**BEFORE THE
ZONING COMMISSION
FOR THE DISTRICT OF COLUMBIA**

Z.C. CASE NO. 20-14

**PREHEARING SUBMISSION
FOR DESIGN REVIEW
IN THE
M AND SOUTH CAPITOL STREETS SUB-AREA**

SQUARE 649, LOTS 43, 44, 45 & 48

Figure A

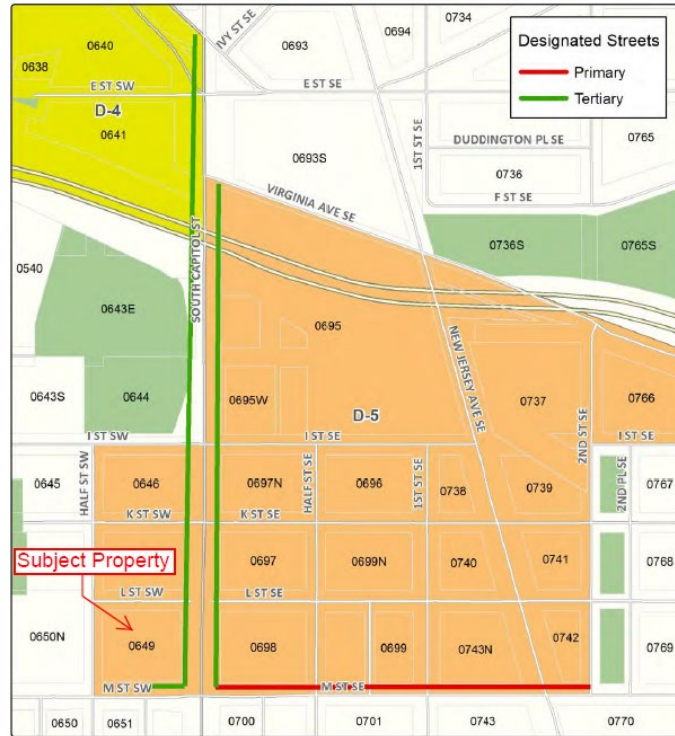
The streetwall of buildings located on the east and west sides of South Capitol Street are required to be setback for their entire height and frontage no less than 15 feet from the property line adjacent to South Capitol Street. The goal of this setback requirement along South Capitol Street is to create a boulevard having a consistent view corridor that is 160-foot wide. However, a setback from South Capitol Street is not required for the Property pursuant to 11-I DCMR § 616.7(a), stating that “[t]here shall be no setback on the west side of South Capitol Street in Square 649 between L and M Streets, S.W.” This exemption exists because the South Capitol Street right-of-way has already been widened in this location based on previous right of way dedication from Square 649. *See **Figure A** above.*

As shown in **Figure A**, the lots in Square 649 are already setback from the required South Capitol Street setback line, thus creating the intended view corridor. As such, the proposed building projections as well as the added balconies allow the façade to be brought closer to the line of the view corridor and create visual interest similar to other buildings that have façade articulation behind the setback line (e.g., the recently approved residential building at 950 South Capitol Street, SE). At the same time, the goal of the consistent street wall along South Capitol Street is achieved. The strong architectural framing of the columns creates a consistent street wall as one looks to the north and south along South Capitol Street, and in the Residential Scheme, the
